Issue with 50G PAM4 C2M Specification

IEEE 802.3cd Task Force Meeting

Jan 11th, 2017

- ❑ In support of comment 116 against P802.3cd D1.1
- ❑ The IEEE 802.3bs C2M simulations have not demonstrated operation over 10.5 dB channel with max FEXT/NEXT
- ❑ The base simulations have consisted of
 - 6 TE channel with a hypothetical connector having crosstalk $\sim 1/5$ of QSFP28
 - 2 Cisco channels with no crosstalk
- ❑ History of comments on this issue
 - This issue was first raised with Comment 128 against P802.3bs draft 1.4 that mated board of CL92 crosstalk is excessive in support of 50G Cu cabling
 - Comments 83 and 86 are submitted against D2.0 related to excessive crosstalk not considered in the baseline C2M
 - Comments 135 against D2.1 related to excessive crosstalk not considered in the baseline C2M
- ❑ C2M simulations need to be repeated with representative QSFP28 channels otherwise we are building an standard based on a hypothetical MDI!

Bases for the Mated MCB/HCB MDFEXT/MDNEXT in CL92

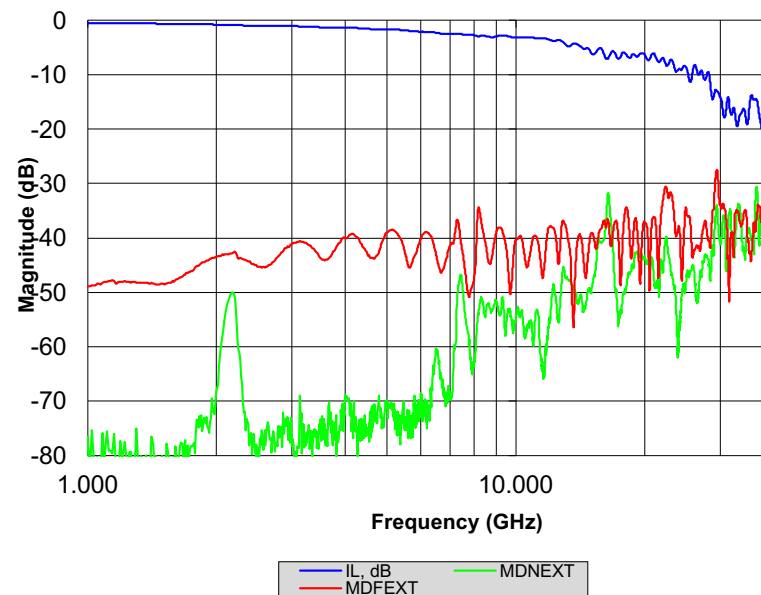
❑ QSFP+ connector provided bases for the CL92 MDFEXT and MDNEXT

- QSFP28 does provide slight improvement but in 802.3cd decided to stay with these legacy limits
- http://www.ieee802.org/3/bj/public/sep12/ghiasi_3bj_01a_0912.pdf

Crosstalk for C2M Test Case 3 and 5

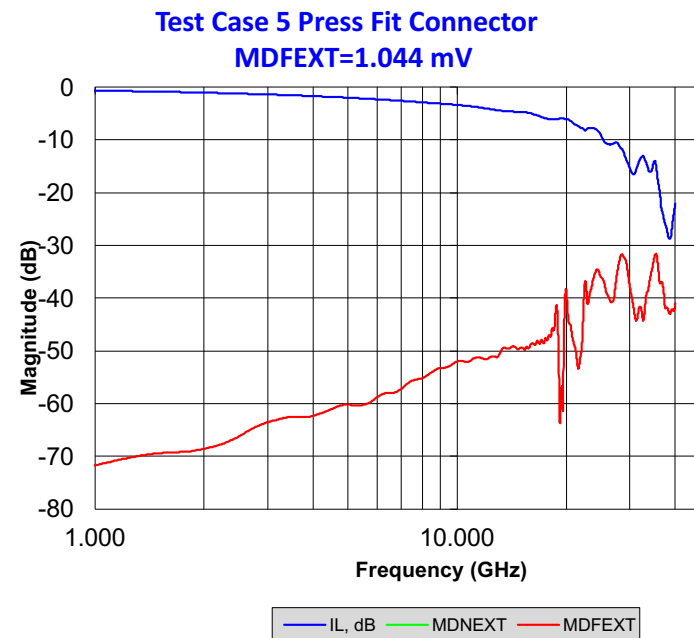
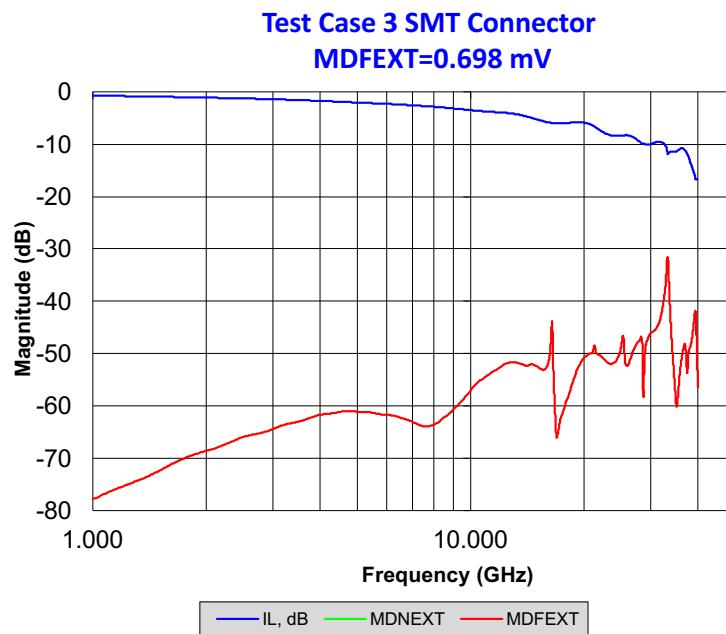
❑ Mated board had no NEXT and with excellent FEXT

- http://www.ieee802.org/3/bs/public/channel/TEC/shanbhag_3bs_01_1014.pdf
- C2M are based on channels with 5-7x lower crosstalk than mated board referenced currently!
